10 East Road, N1

proposed south block
south elevation

PA183

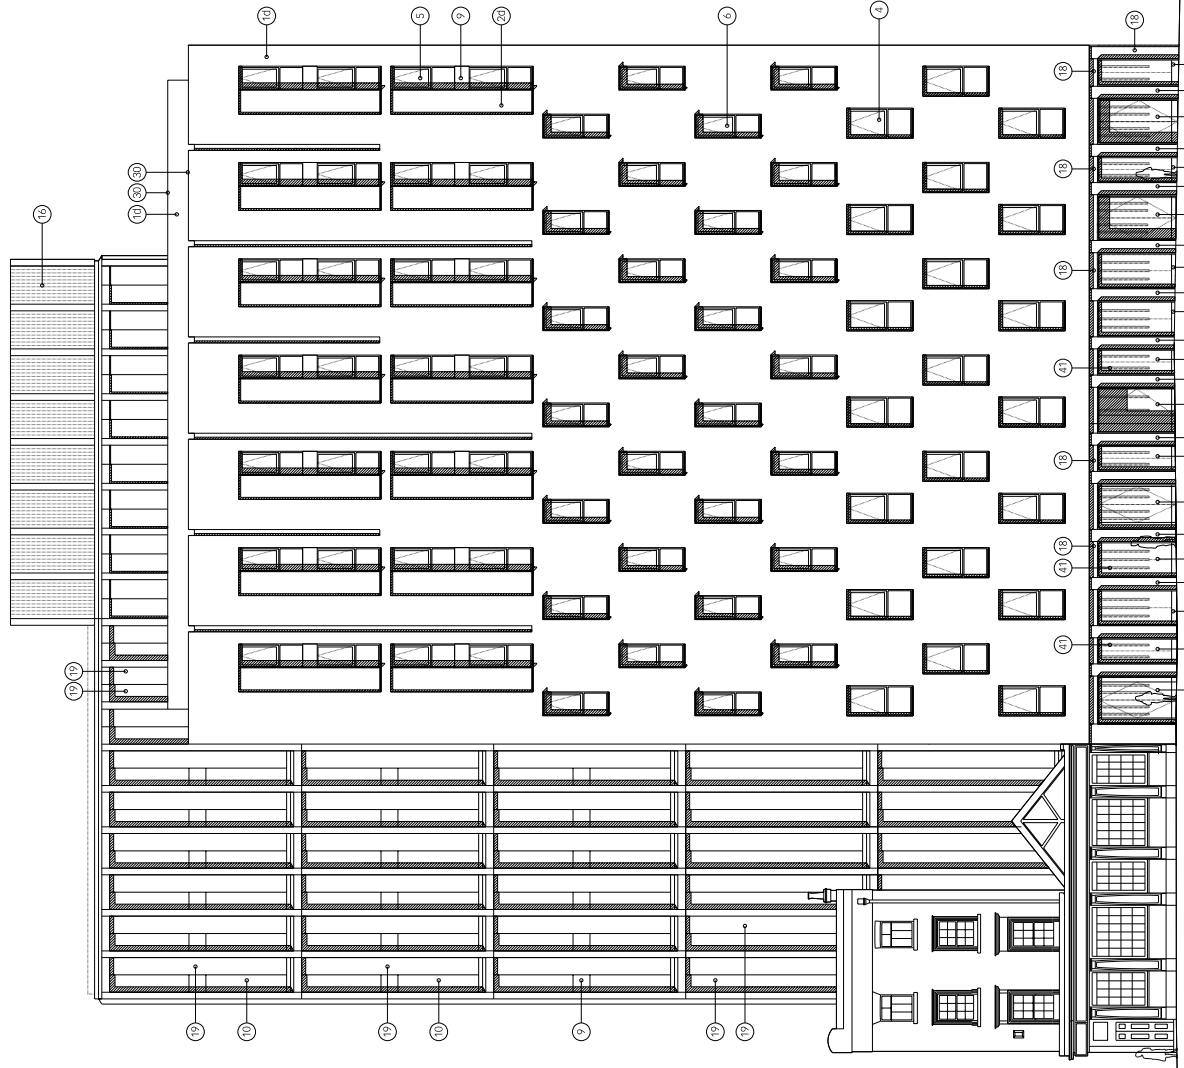
hotel window types revised, office floor revised, facade as ground floor revised, layout of plant screen revised, height level of office parapet amended, legend and annotations amended.
